CD Series 5 Extended IO C9 Connector

Overview with corrected pinouts shown (note this is per documentation and not verified):

CD Series 5 Top view

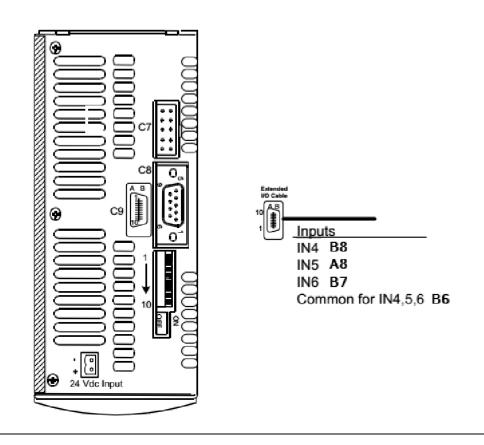
Original document with discrepancies (the pin#s are incorrect).

Pin #	Function	Description	Comments
A3	IN5		Bipolar
B3	IN4		Bipolar
B4	IN6		Bipolar
B5	Common For IN4 to IN6	Common For IN4 to IN7	Source or Sink

Corrected pin-out: note this is per documentation but not verified:

Pin#	Function	Description	Comments
A8	IN5		Bipolar
B8	IN4		Bipolar
B7	IN6		Bipolar
B6	Common for IN4 to IN6		Source or Sink
